Proposal for editorial correction to ECE/TRANS/WP.29/GRE/42

(Collective amendments to Regulations Nos. 3, 6, 7, 48, 77 and 91)

A. Proposal for Supplement 11 to the 04 series of amendments to Regulation No.48

Figure (see paragraph 6.5.)

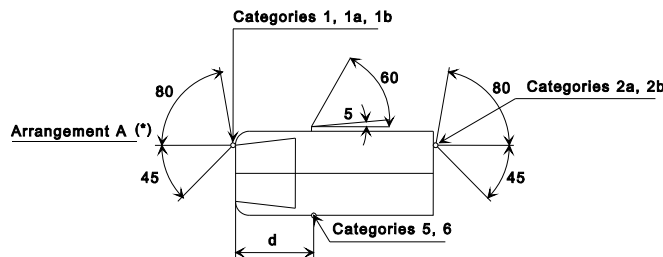
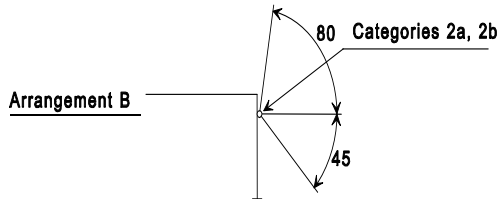
~~Vertical angles: 15° above and below the horizontal for direction indicator lamps of categories 1, 1a, 1b, 2a, 2b and 5. The vertical angle below the horizontal may be reduced to 5° if the lamps are less than 750 mm above the ground; 30° above and 5° below the horizontal for direction indicator lamps of category 6. The vertical angle above the horizontal may be reduced to 5° if the optional rear lamps are not less than 2,100 mm above the ground.~~

~~For M_1 and N_1 category vehicles, the value of 45° inward for the direction indicator lamps of categories 1, 1a or 1b, whose lower edge of the apparent surface is less than 750 mm above the ground, may be reduced to 20° under the horizontal plane containing the reference axis of this lamp.~~

Vertical angles: 15° above and below the horizontal for direction indicator lamps of categories 1, 1a, 1b, 2a, 2b and 5.

- where a lamp is mounted below 750 mm (measured according to the provisions of paragraph 5.8.1), the downward angle of 15° may be reduced to 5°;
- where an optional rear lamp is mounted above 2,100 mm (measured according to the provisions of paragraph 5.8.1) the upward angle of 15° may be reduced to 5°.

30° above and 5° below the horizontal for direction indicator lamps of category 6.

For the direction indicator lamps of categories 1, 1a, 1b, 2a and 2b mounted below 750 mm (measured according to the provisions of paragraph 5.8.1), the inward angle of 45° may be reduced to 20° under the H plane.

6.5.5.2. or, at the discretion of the manufacturer, for M₁ and N₁ category vehicles: Front and rear direction indicator lamps, as well as side-marker lamps (**).

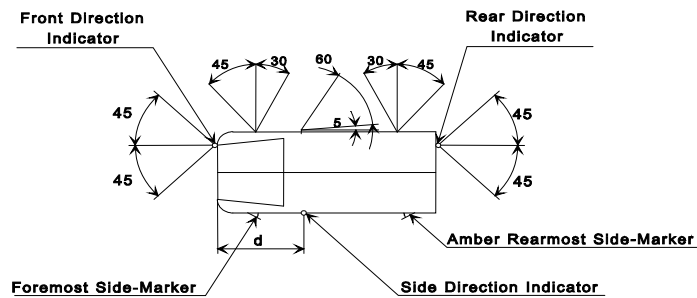
The value of 45° inward for the direction indicator lamps of categories 1, 1a or 1b, whose lower edge of the apparent surface is less than 750 mm above the ground, may be reduced to 20° under the horizontal plane containing the reference axis of this lamp.

~~Vertical angles: 15° above and below the horizontal. The vertical angle below the horizontal may be reduced to 5° if the lamps are less than 750 mm above the ground.~~

However, for the direction indicator lamps of categories 1, 1a, ~~or 1b~~ 2a and 2b mounted below 750 mm (measured according to the provisions of paragraph 5.8.1), the inward angle of 45° may be reduced to 20° under the H plane.

Vertical angles: 15° above and below the horizontal. However, where a lamp is mounted below 750 mm (measured according to the provisions of paragraph 5.8.1), the downward angle of 15° may be reduced to 5°.

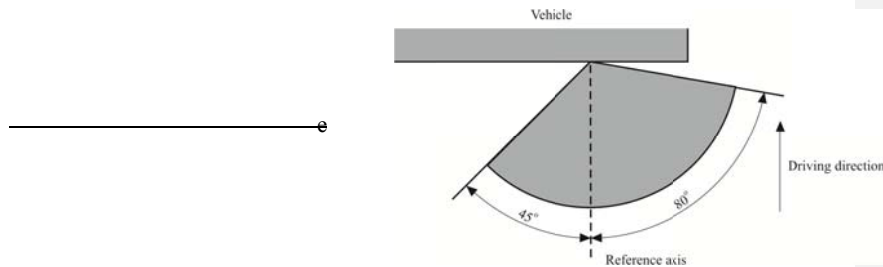
Comment [G.R.D1]:
 This is the correction of the text shown in GRE/2012/42
 During the preparation of this proposed collective amendment the replacement of the wording “reference axis” by “H-Plane” was erroneously omitted in the proposal C.

- (a) Direction indicator lamps **intended to be installed with the H plane the reference axis of the lamp at** with a mounting height of ~~equal to or~~ less than 750 mm above the ground, for which they are 15° above and 5° below the horizontal;
- (b) **Optional direction indicator lamps intended to be installed with the H plane the reference axis of the lamp at a mounting height of more than 2100 mm above the ground, for which they are 5° above and 15° below the horizontal;**
- (c) Direction indicator lamps of Category 6, ...
